# US 1/SR 4 Widening and Oak Park Bypass

EDS-545(14)(17)(18) Toombs and Emanuel Counties

## Value Engineering Study Report Preliminary Design Stage

ALT II-8  
SHT 2 OF 5

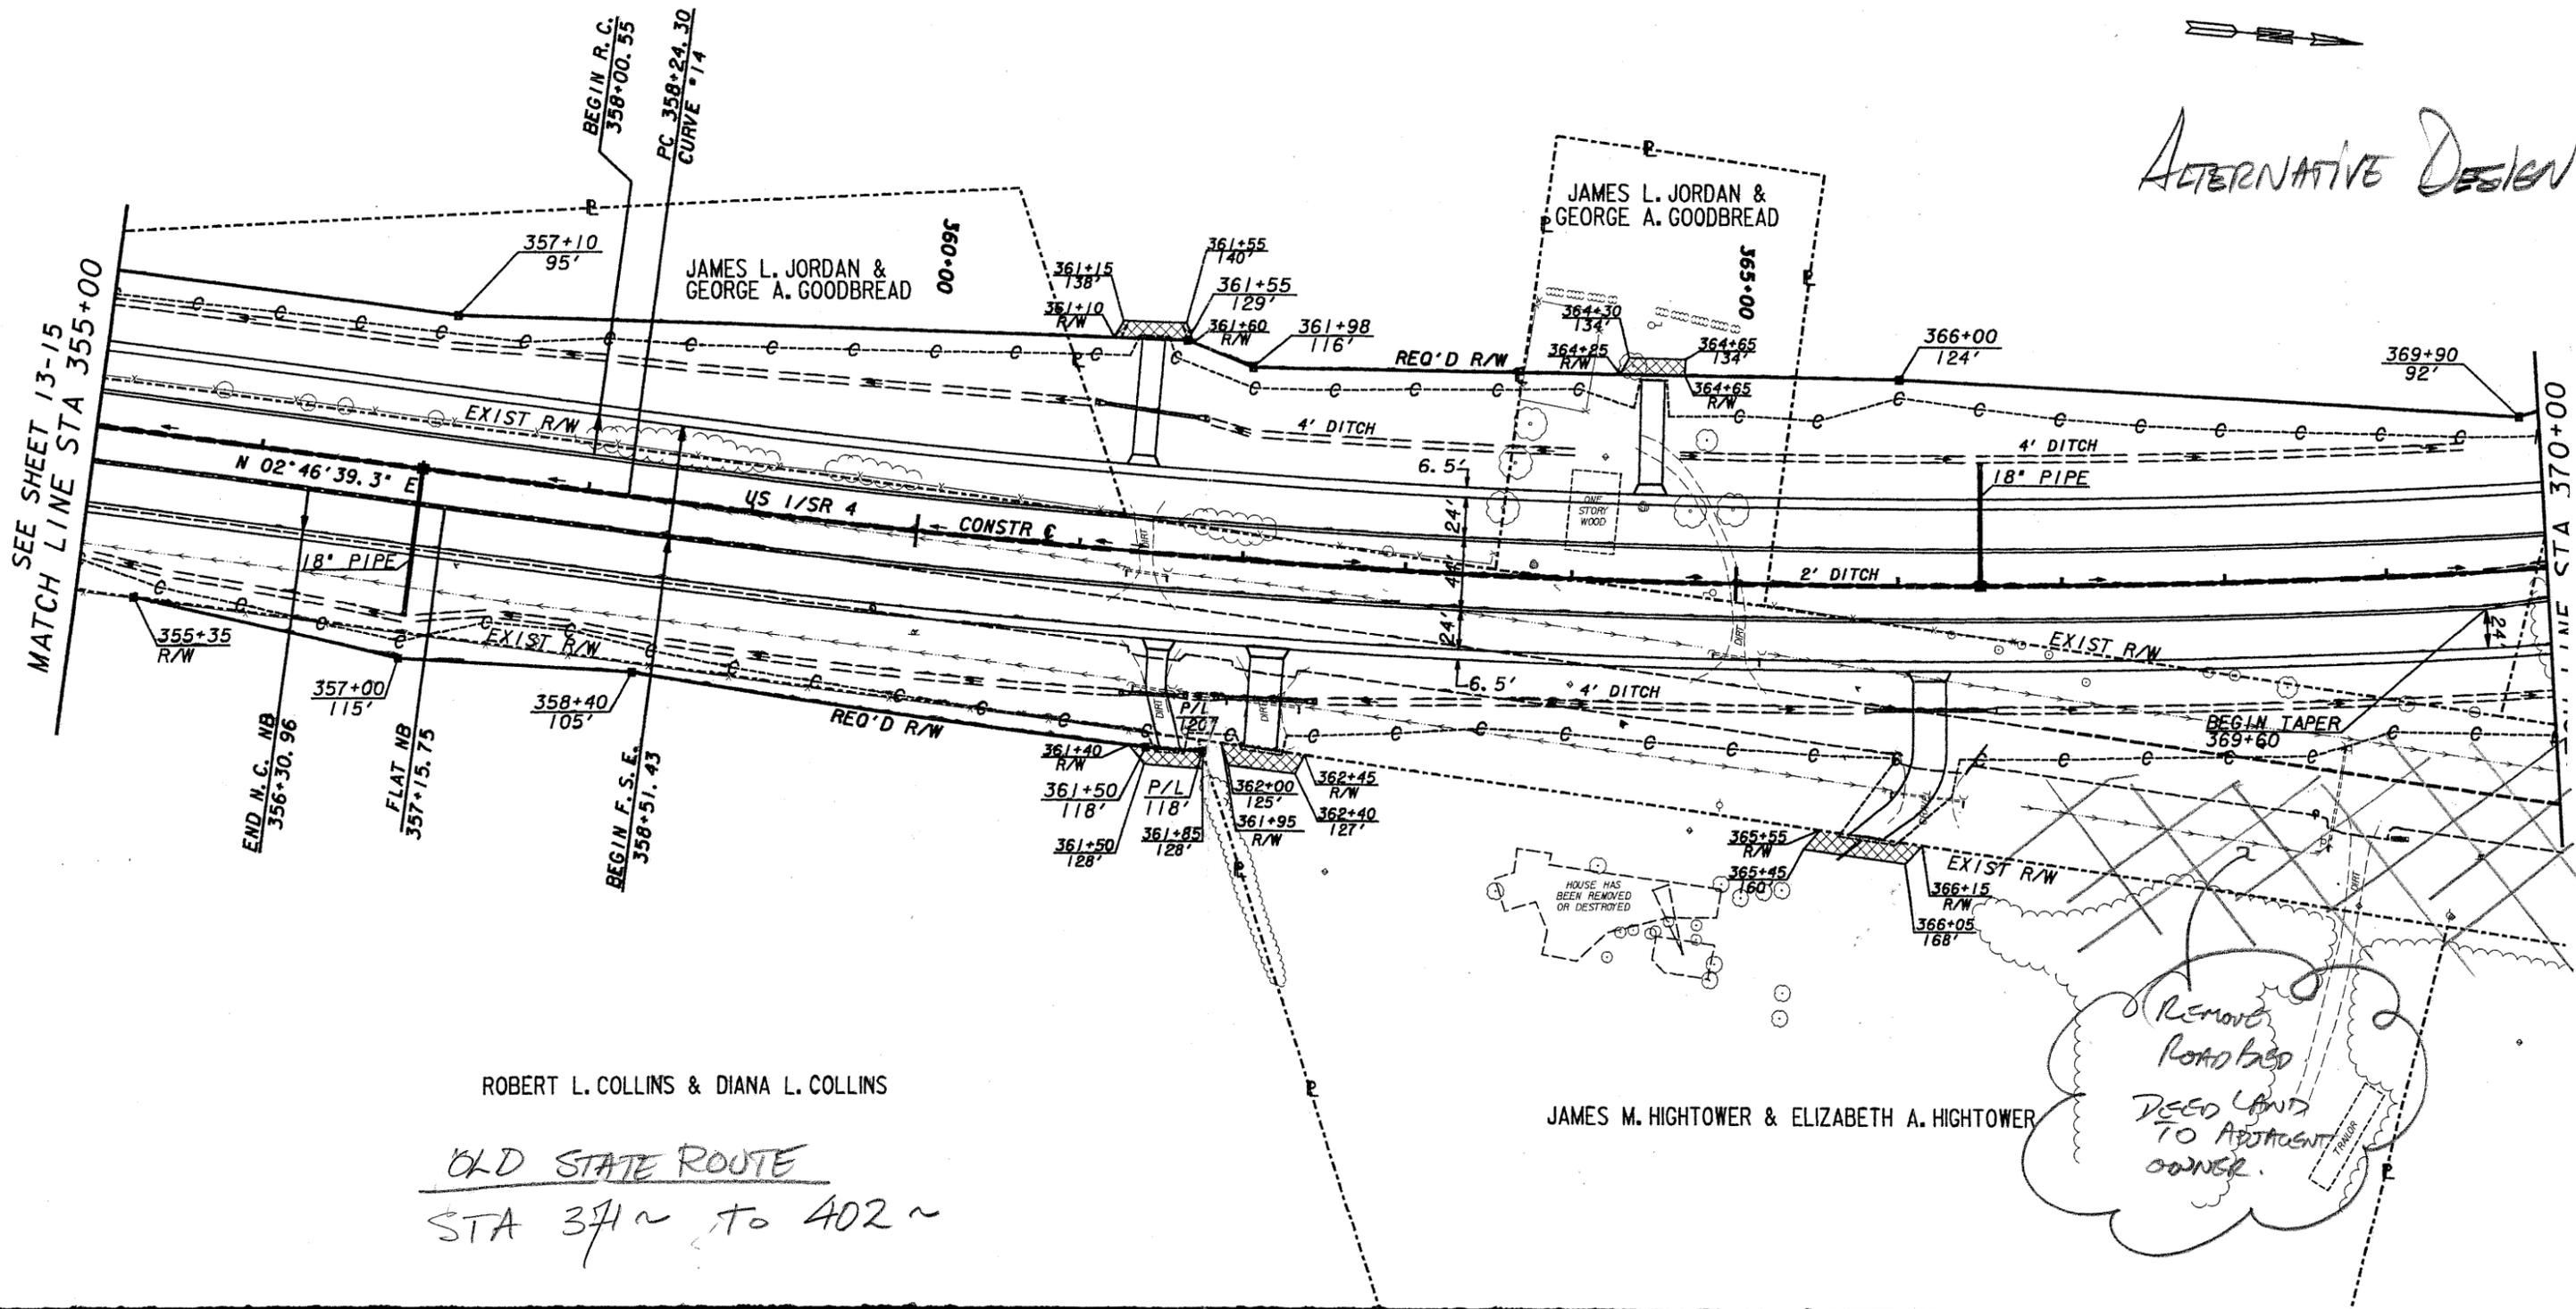
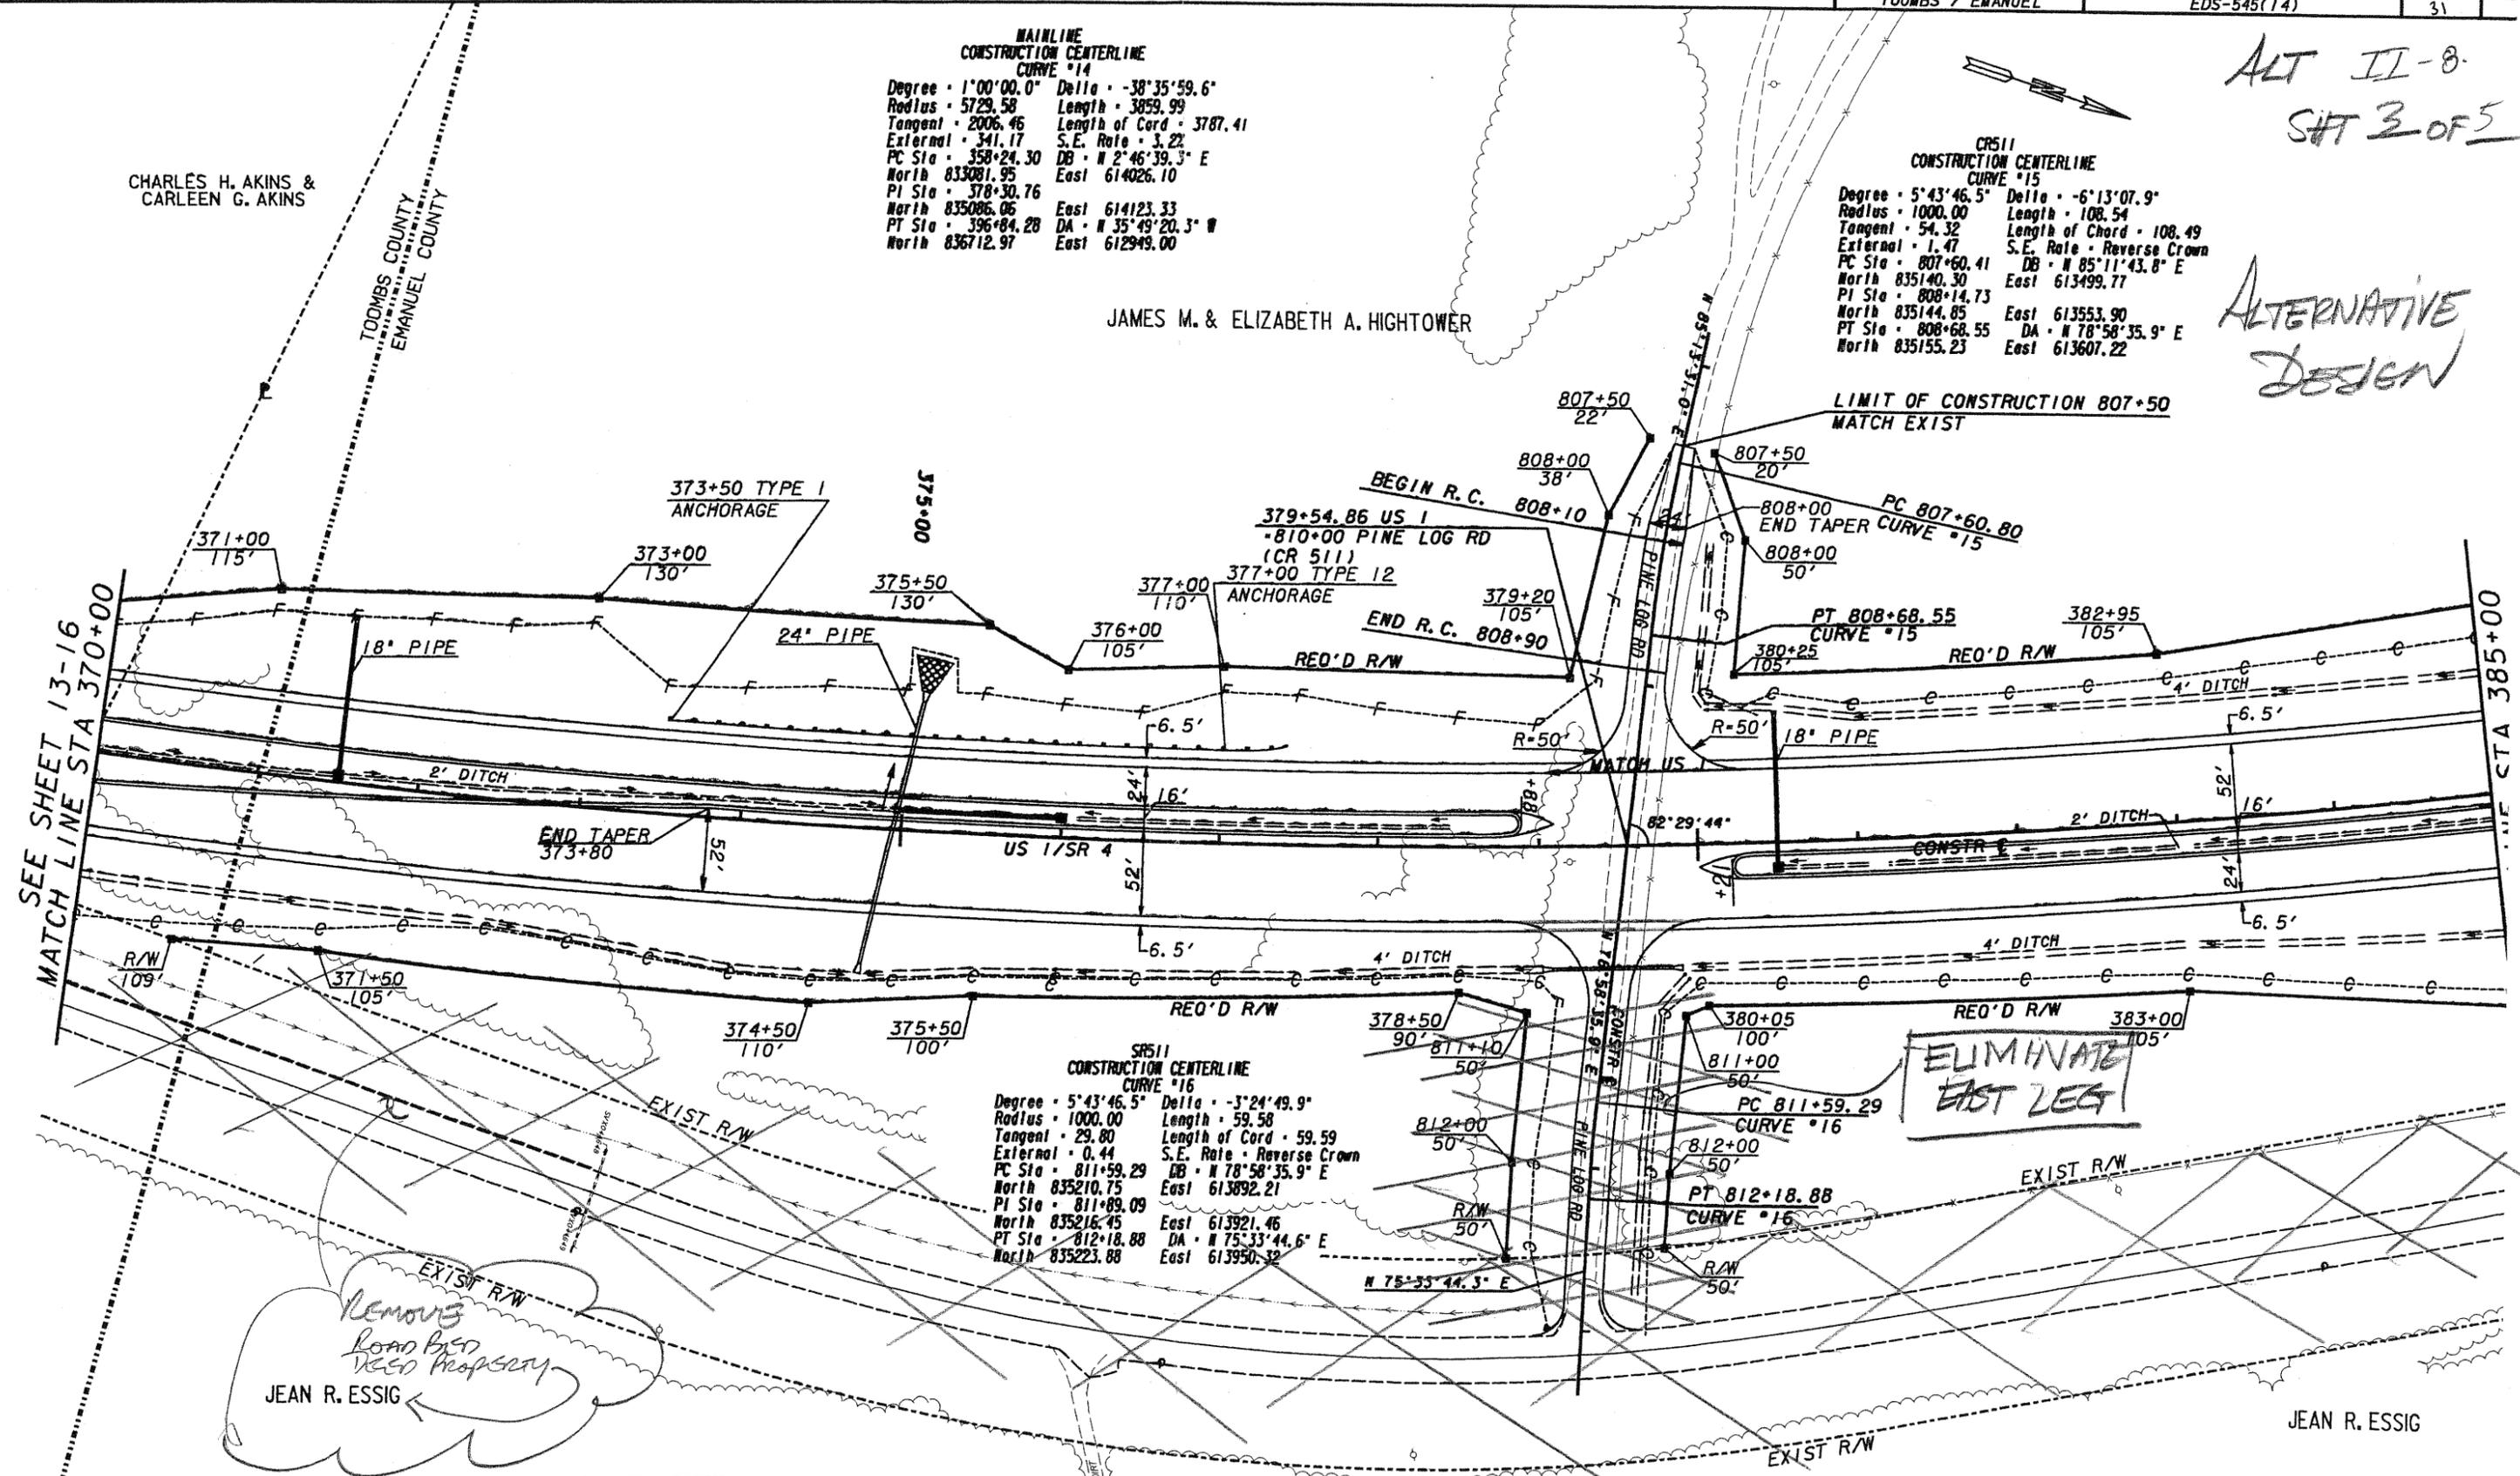
Remove Roadbed  
DEED LAND TO ADJACENT  
OWNER.

Remove Road Base Used Property  
 JEAN R. ESSIG

Remove Road Bed Used Property TO JEAN R. ESSIG
